**PRESTON PLAINS MIDDLE SCHOOL
SCIENCE LAB
1 ROUTE 164
PRESTON, CT 06365**

Addendum # 05
February 11, 2020

Kewaunee Matrix Instructor Station

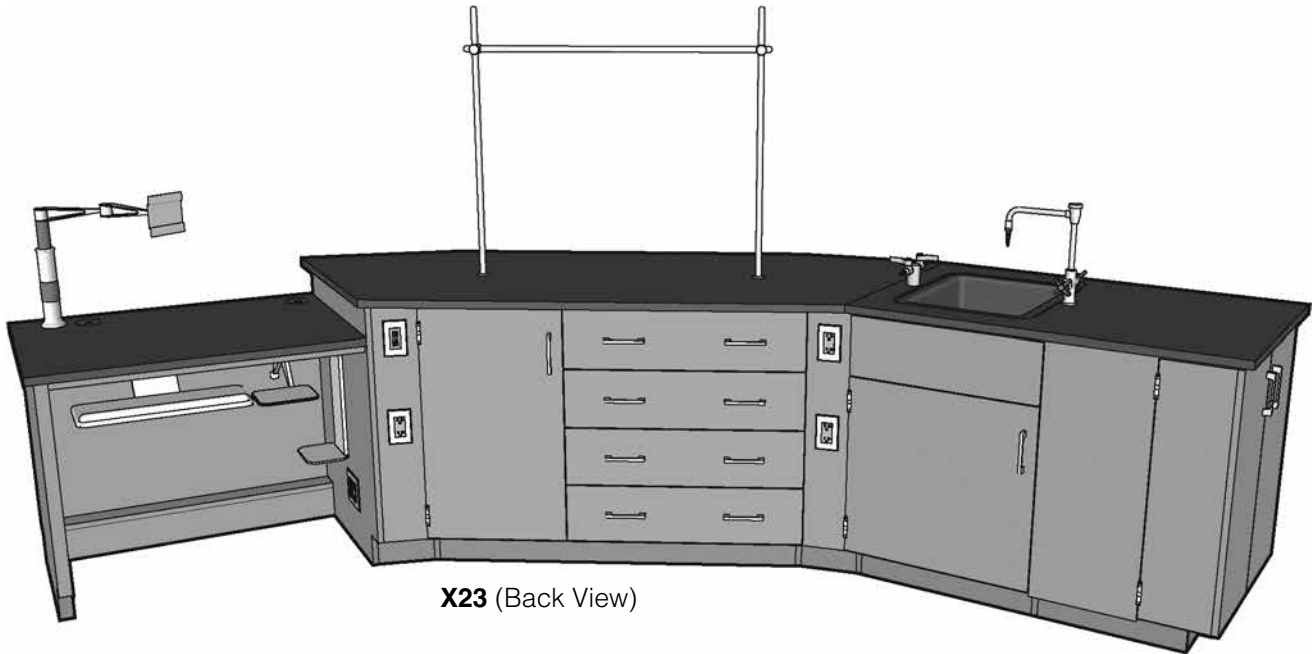
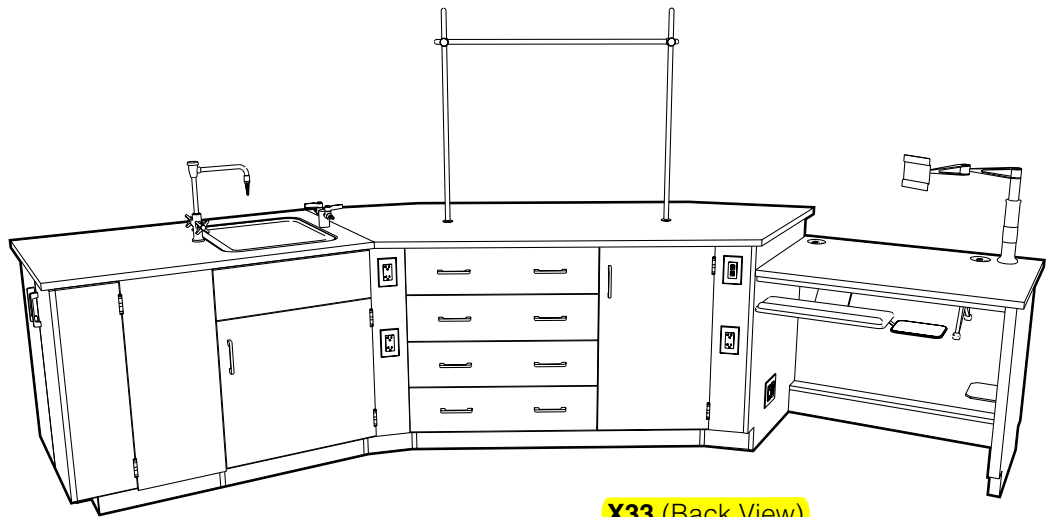
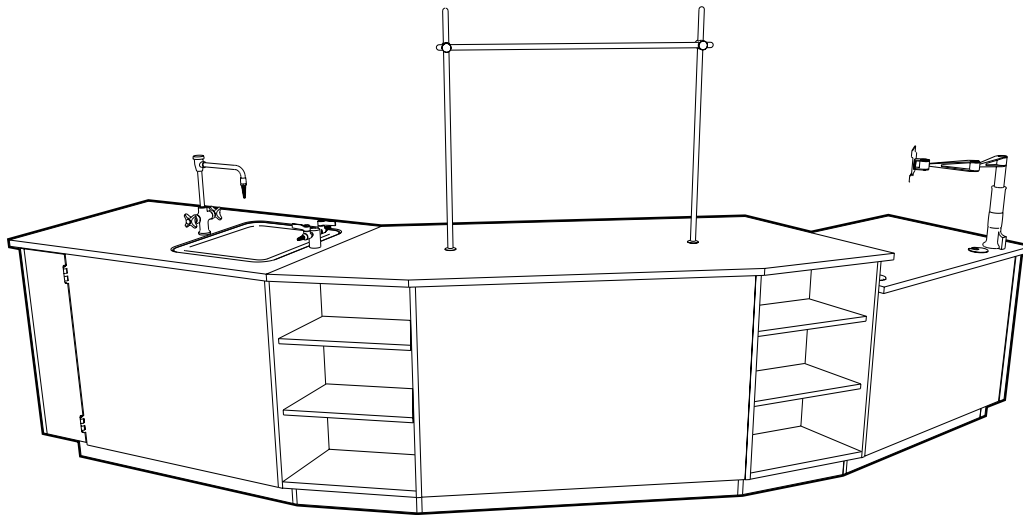
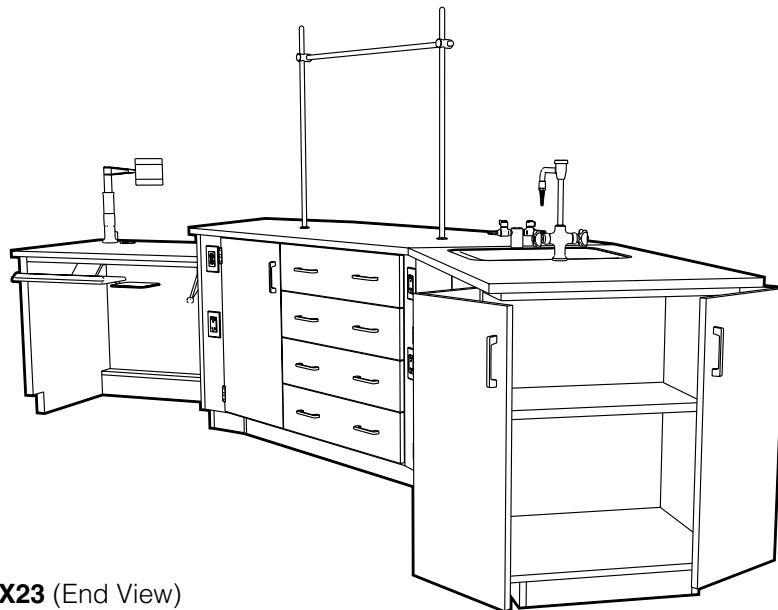
1.	See attached bidder question log dated 2/11/20	Attached
2.	In response to Bidder Question 31, see the attached Basis of Design cut sheet for TD1: Kewaunee Matrix Instructor Station – Model X23. Product changes from basis of design model should include all identified fittings and accessories in the attached cut sheet including those indicated in the drawings and specifications.	Attached
3.	In response to bidder question 34, see attached Isimet utility controller product information.	Attached

All highlighted information is included in the basis of design product and should be included in the G.C.'s scope of work.
